Diversified Metal Fabricators Service Bulletin SB 2049

Title	RW-1019 Long Arm Slots Issues for 2005-2006 Ford F-450/550's
Document No.	SB 2049
Issue Date	12/27/06 (WAK)
Units Affected	2005-06 Ford F-450s and F-550s
Purpose	This service bulletin addresses a product improvement for RW-1019 front railgear on model year 2005 and newer Ford F-450's and F-550's.

Fig. 1: Older Longarms - to be replaced

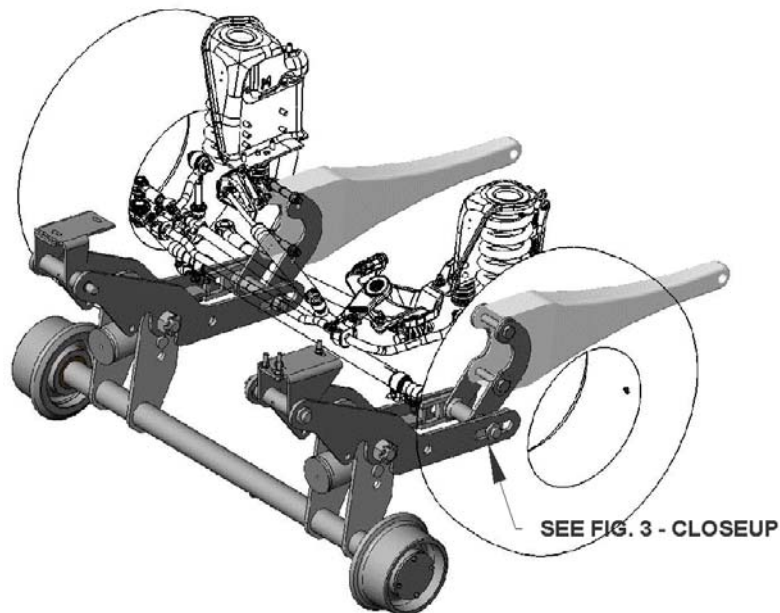
The following longarms should be replaced:

- Longarms with front slots
- Longarms with rear slots without guide rails & slide bars (see Fig. 1)

These arms will be replaced with new longarms that use a guide rail and slide bar (see Fig. 2 & Fig. 3). Long arms will be provided with new pins, washers and nuts.

Fig. 3: New Longarms - Closeup

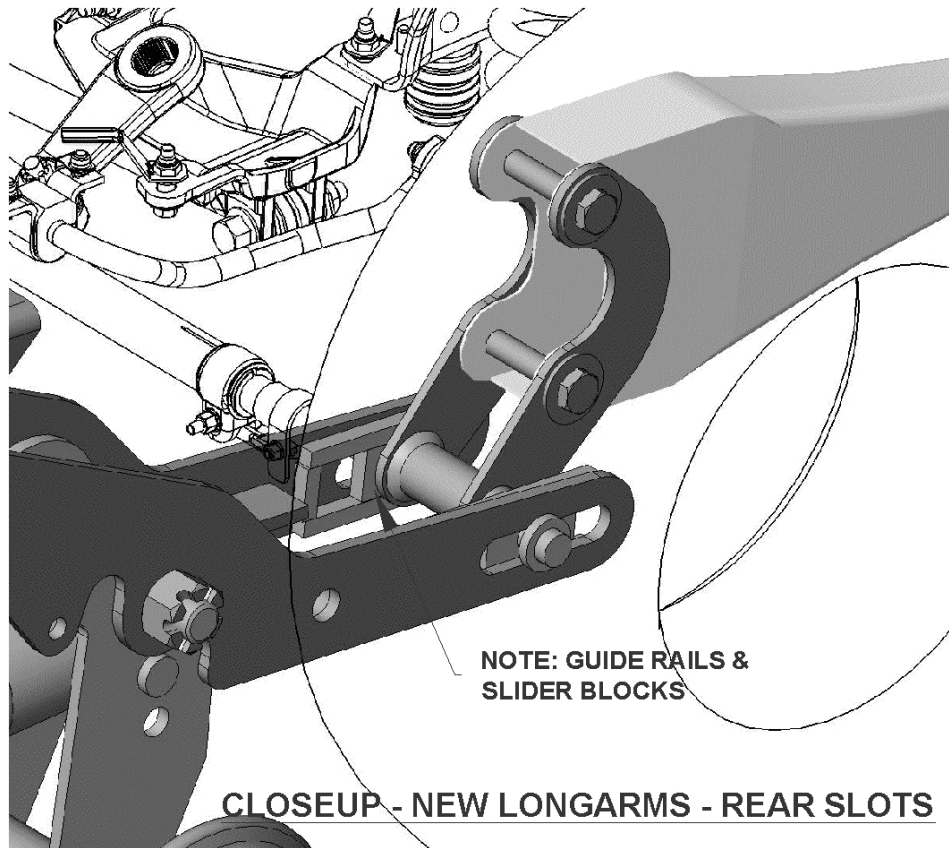
In order to address these wear issues, several configurations (front slots, rear slots) were tried. We have standardized on a rear slot arrangement which uses bearing rails and a sliding bar.
